PLAN-009639

Proposal: Side & rear single storey extension (resubmission following M/10/15/HH).

Site: 37 Lane End Road, Ancton, Middleton-on-Sea PO22 6LT.
M/42/15/HH

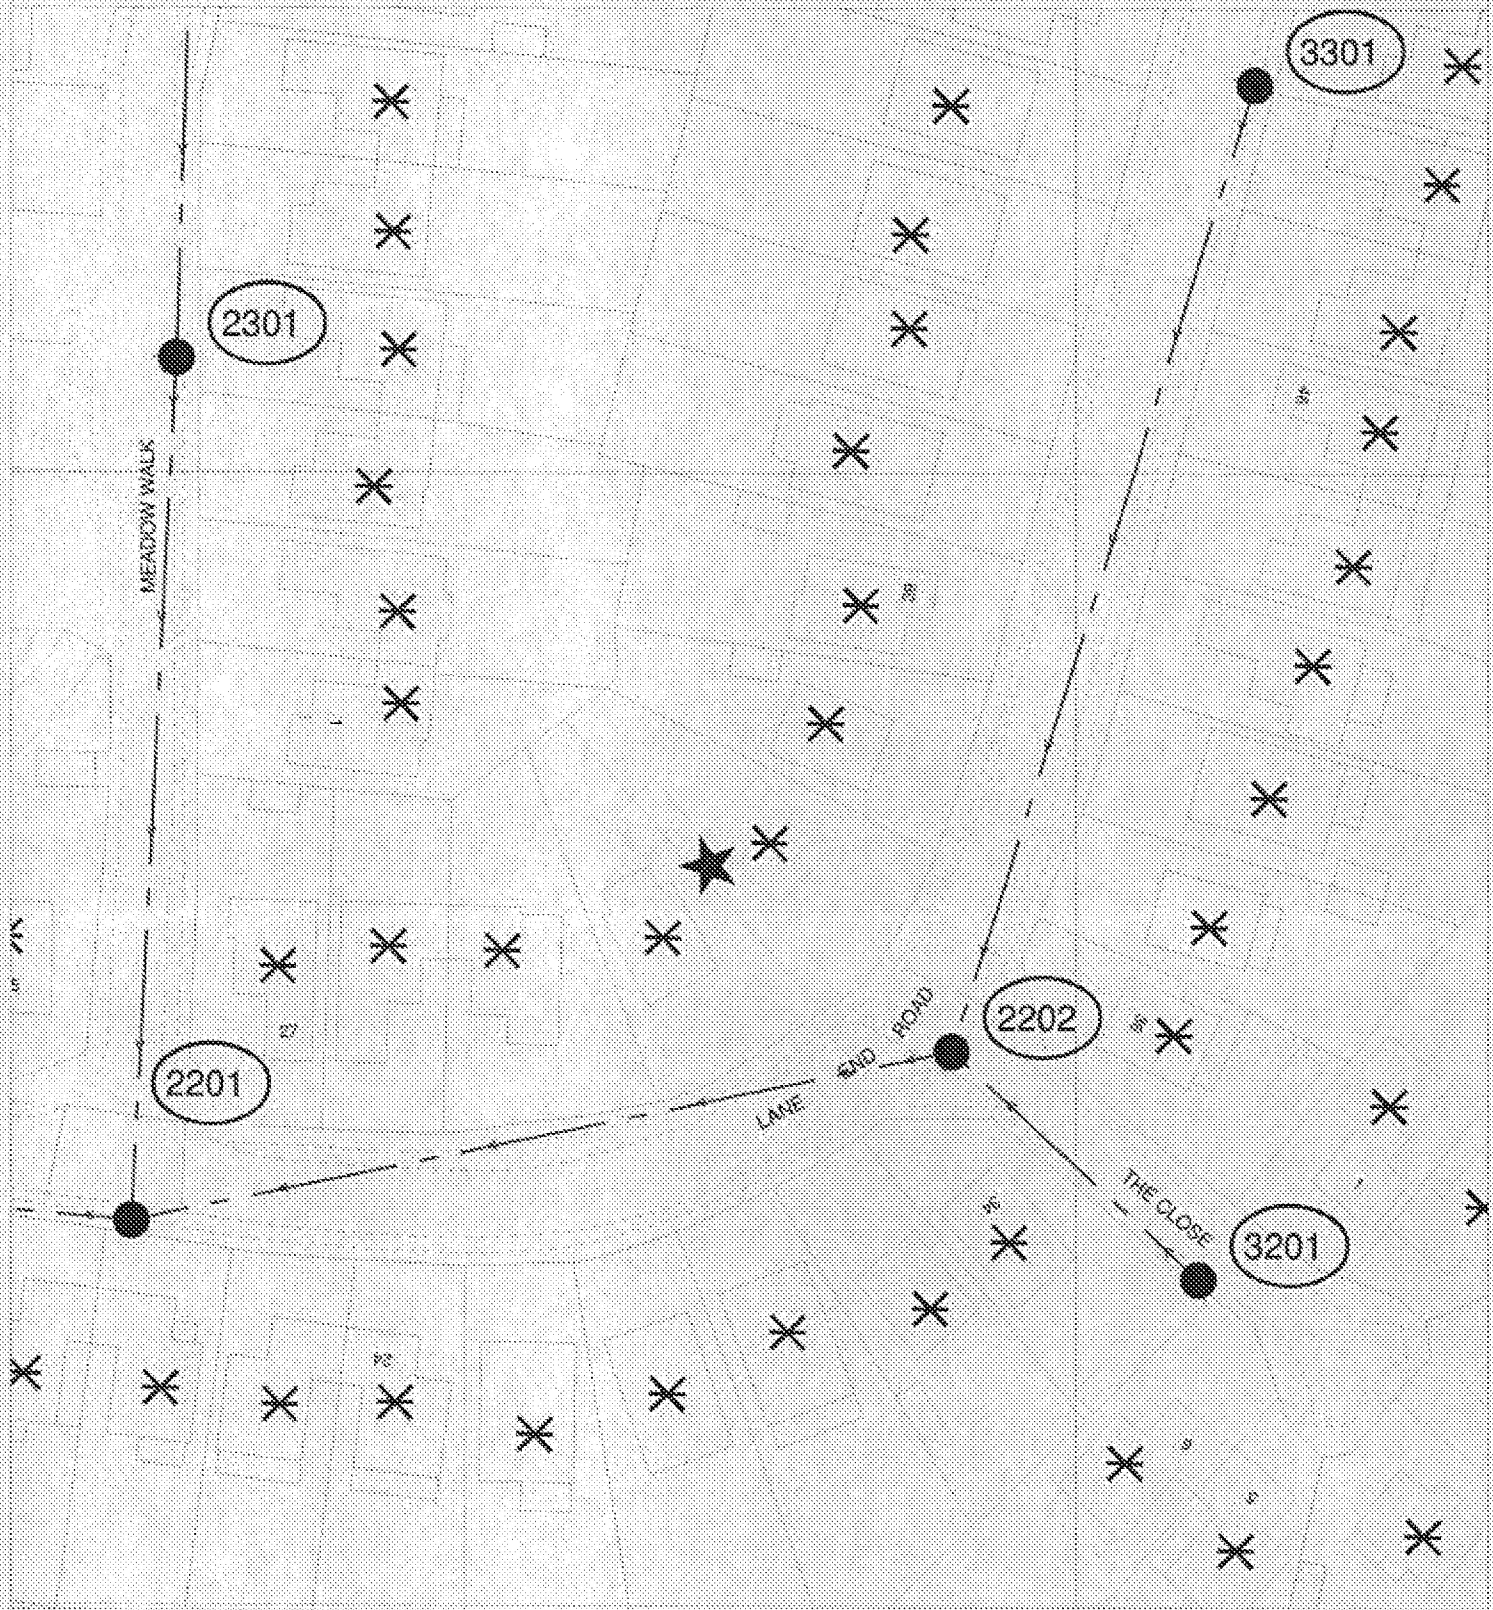
Due to changes in legislation that came in to force on 1st October 2011 regarding the future ownership of sewers it is possible that a sewer now deemed to be public could be crossing the above property. Therefore, should any sewer be found during construction works, an investigation of the sewer will be required to ascertain its condition, the number of properties served, and potential means of access before any further works commence on site.

The positions of pipes shown on this plan are believed to be correct, but Southern Water Services Ltd accept no responsibility in the event of inaccuracy. The actual positions should be determined on site.

The applicant is advised to discuss the matter further with Southern Water, Sparrowgrove House Sparrowgrove, Otterbourne, Hampshire SO21 2SW (Tel: 0330 303 0119) or www.southernwater.co.uk.
